Re: **The Markets at Bent Grass
Roundabout Analysis Memorandum**

The intent of this memorandum is to respond to a comment provided by El Paso County on The Markets at Bent Grass Master Traffic Impact Study (MTIS) completed in March 2026 by SM Rocha. The comment provided by El Paso County stated “provide roundabout parameters table and exhibits including fastest path speeds and differentials, dimensions, widths, view angles, etc. Discuss specific needs and examples with staff. Include design vehicle and WB-67 tracking exhibits.” The following memorandum will address this comment with a roundabout analysis provided herein.

The Markets at Bent Grass
El Paso County, Colorado
(EPC No.: CR-26-01, SP-26-02)

ROUNABOUT LAYOUT

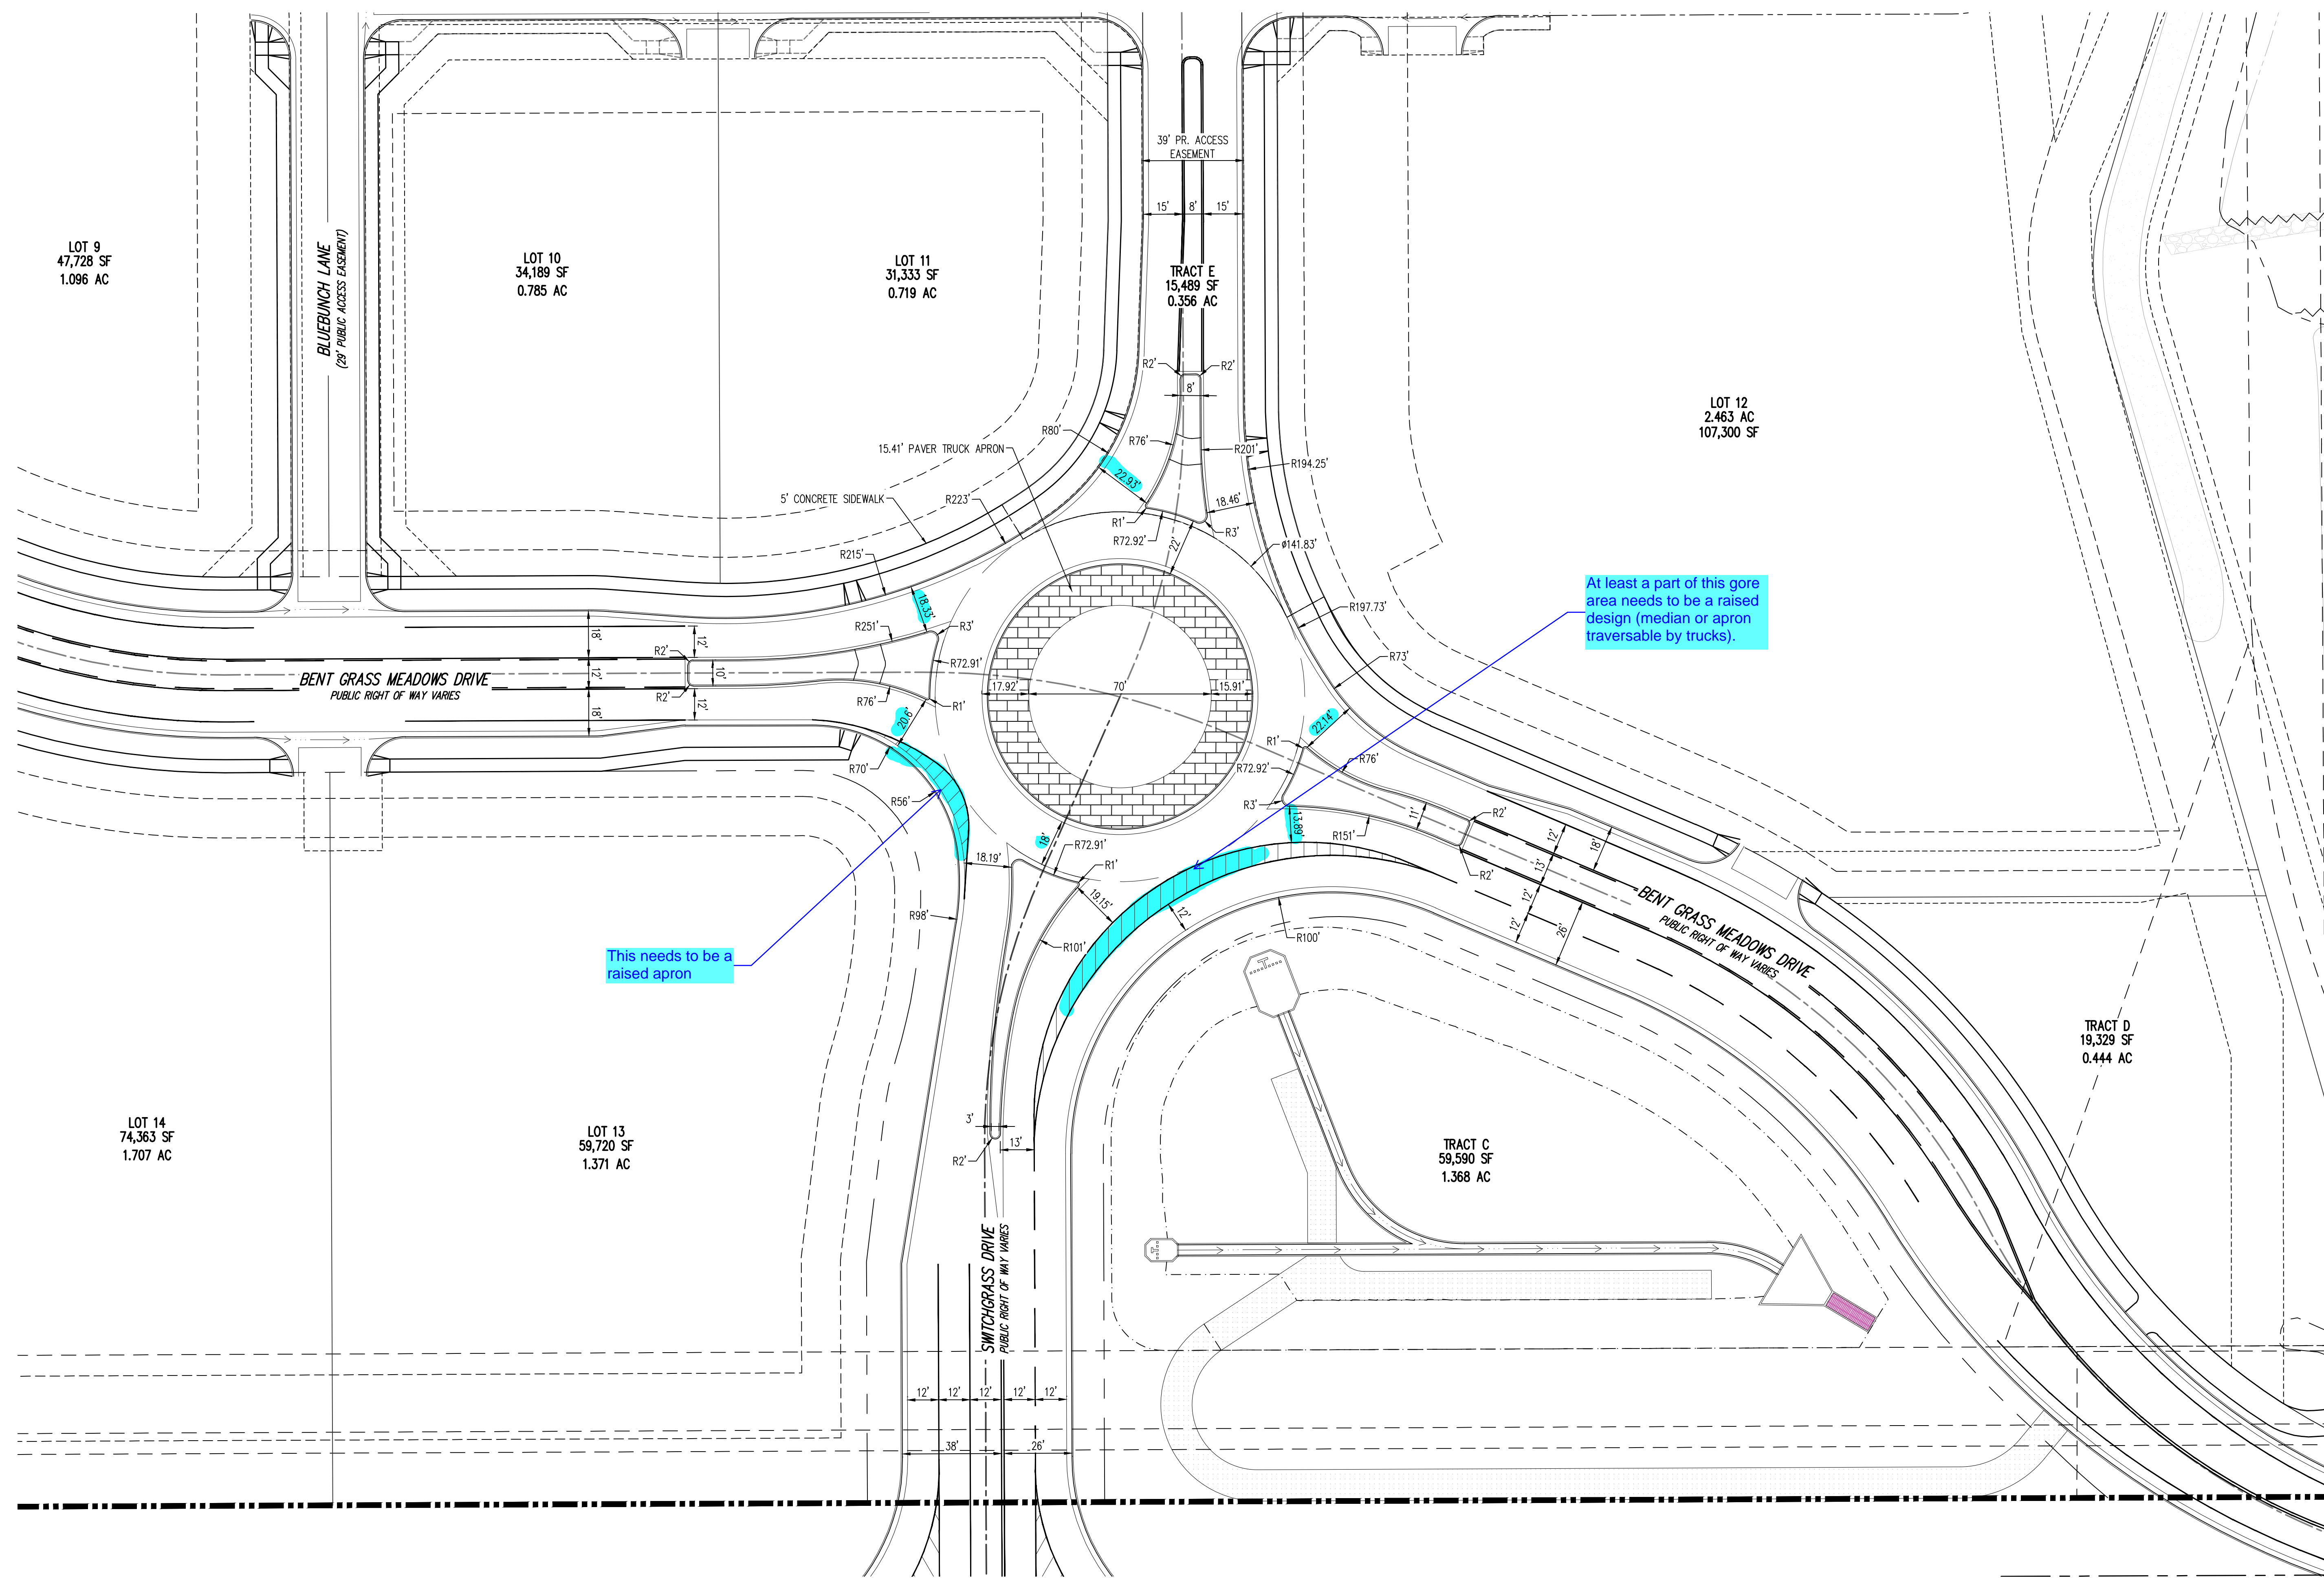
This needs to be a raised apron

At least a part of this gore area needs to be a raised design (median or apron traversable by trucks).

THE MARKETS AT BENT GRASS FASTEST PATH ANALYSIS

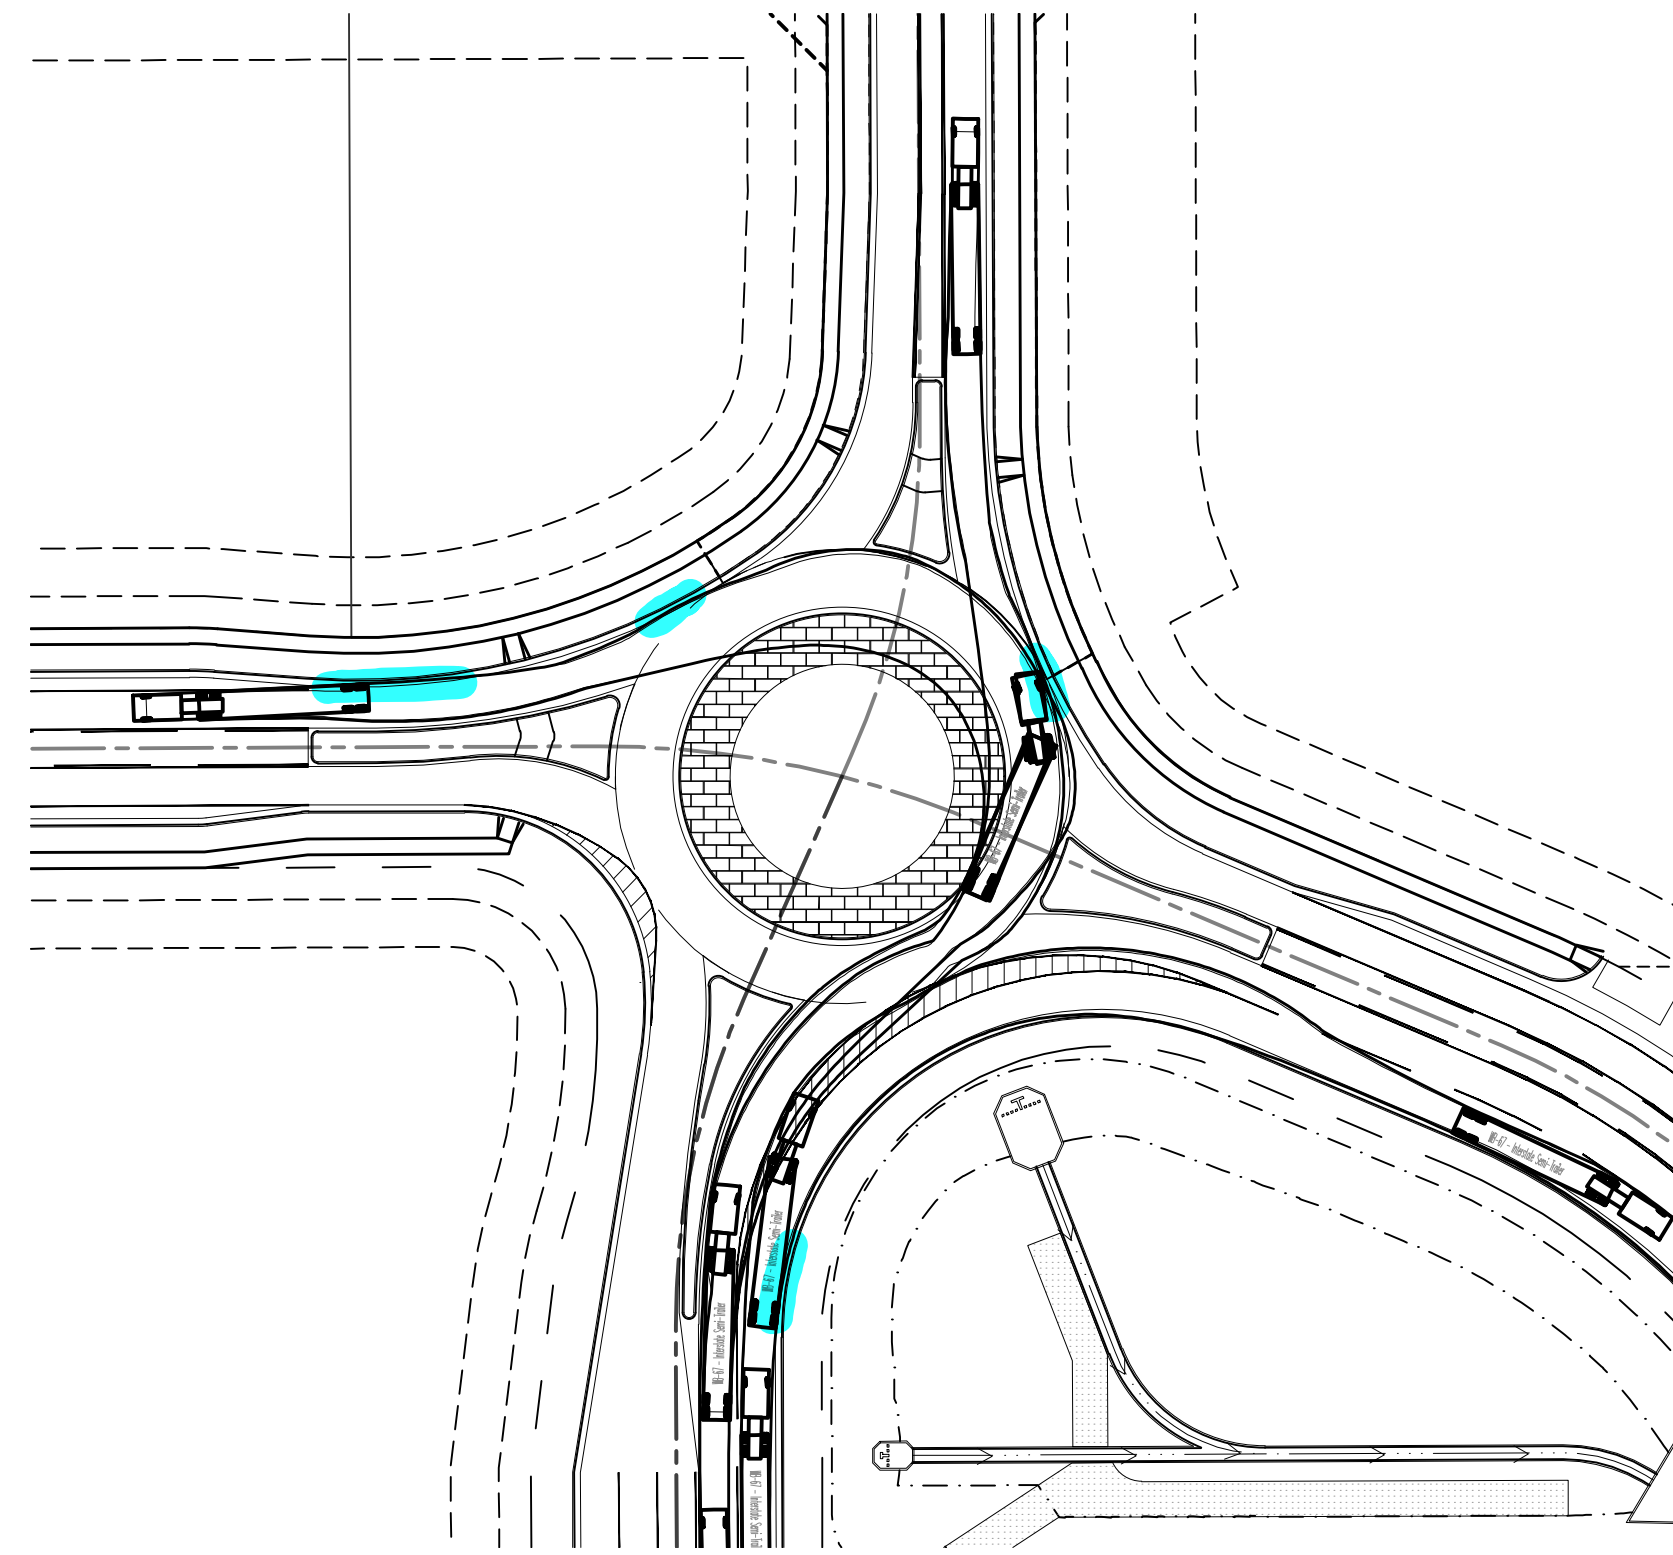
Apron may be needed to slow entry down

speed differential is high

Dimension the offsets used
